SERVICE BULLETINS

VIKING 90 SERVICE BULLETINS

VIKING 110 SERVICE BULLETINS

VIKING 110 INPUT GEAR UPDATE

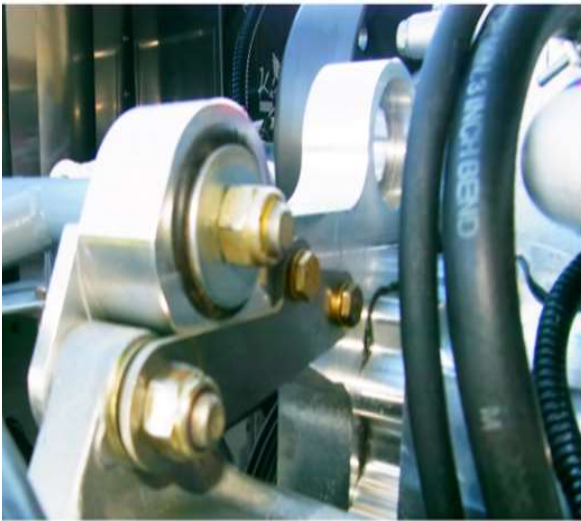
Some early 110 gearboxes have an input gear with more end play than later gearboxes. To inspect for this use one of the following methods.

1. Grab one propeller blade while viewing the drive coupler. Rotate the propeller back and forth to see if these parts move in/out of the gearbox.
2. Use a pry bar and gently pry the coupler towards and away from the gearbox.

You are looking for roughly 0.040 (slightly less than 1/16) of end play to have this “condition” The reason for the inspection is to prevent the drive coupling from physically hitting the back of the gearbox, so also inspect for scraping parts that might indicate such.

It can be inspected yearly, or sent to Viking for a gear replacement

VIKING 110 COOLANT HOSE ROUTING

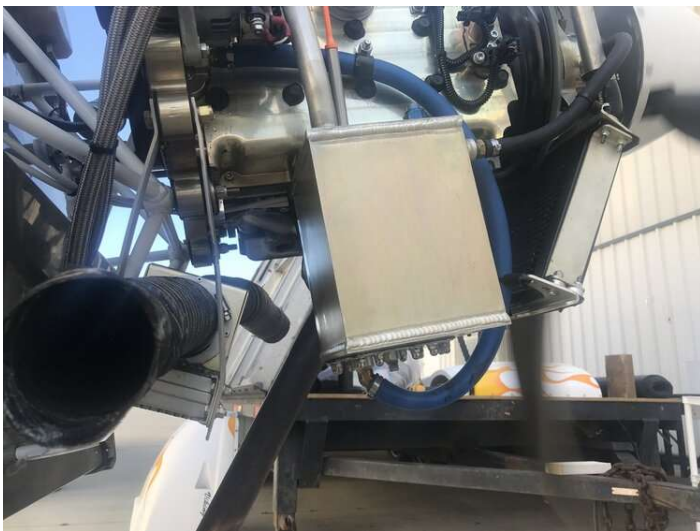
If you have a Viking 110, where the coolant hoses are routed through the gearbox area and the flywheel, please ensure to route it in a different area. This will avoid something happening to the coolant lines, if something were to happen to the gearbox/prop strike so forth and vice versa.

VIKING 110 OIL PICKUP HOSE

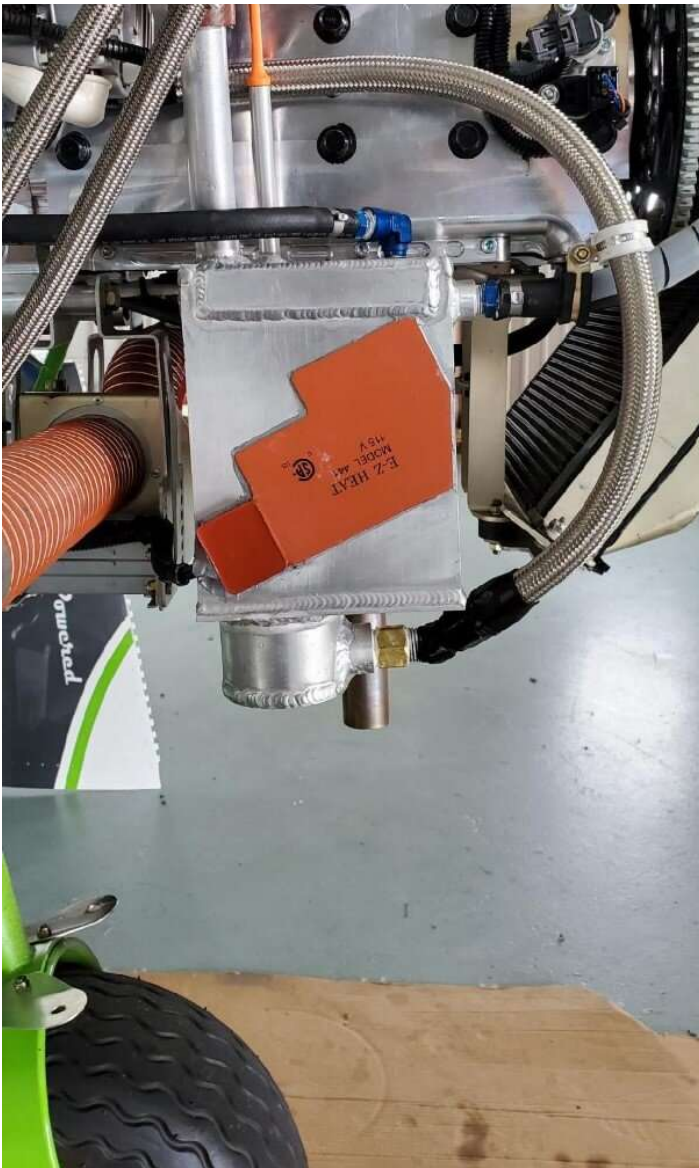
There has been an instance of the top mounted oil pickup tube fracturing and falling into the oil tank. Naturally, when this happens oil pressure is lost. Because all tanks were made

the same way, and there has already been an update prior, to move the oil pickup to the bottom of the tank in order to increase suction, this now becomes a mandatory change. No Viking 110 Engines should fly with a top mounted oil pickup hose after 06/05/2018.

This picture shows the best oil pickup system for the Viking 110 engine. Some engines already have this but might use 1/2" hose, rather than a 5/8 hose and fittings. This particular engine can maintain 55-70 psi of oil pressure.

No 90 degree fittings if possible. 3/8 NPT threads. 5/8 hose barb. 5/8 hose rated for oil and suction.

Example of the best oil tank system: The oil pickup tube should be of the ridged teflon type so it can take the heat and not collapse under suction.

VIKING 110 WIRING UPGRADE

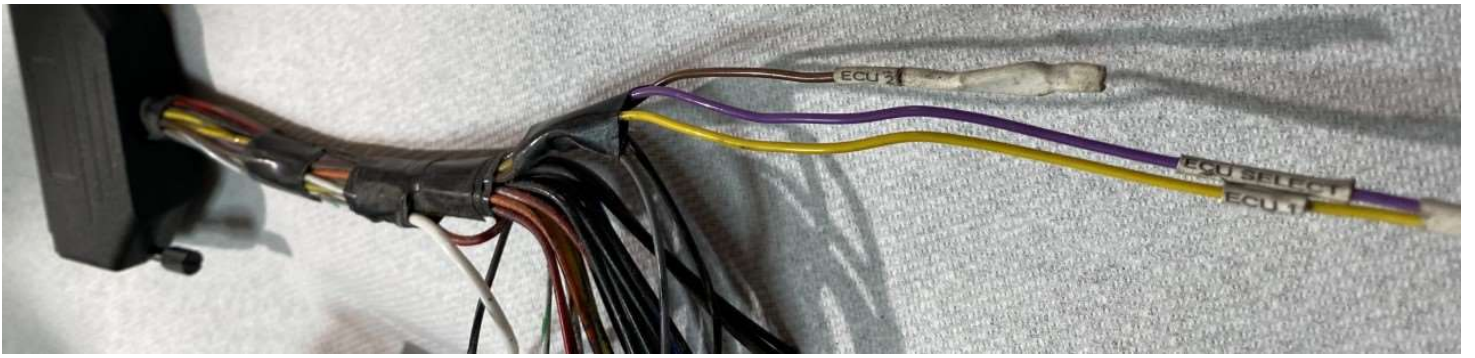
Remove ECU select switch in order to operate on a single computer only. Do this by locating the select switch on the panel, remove the three wires labeled; ECU 1, ECU 2 and SELECT. Disregard and tape the ECU 2 wire. Solder ECU 1 and SELECT together and protect with shrink tubing. If done correctly, the engine will start and run normally and the TAC (RPM) will be working.

The reason for this change is several instances of intermittent operation between ECU 1 and ECU 2 with zero failures of either one.

Locate these wires

Cap and solder as shown.
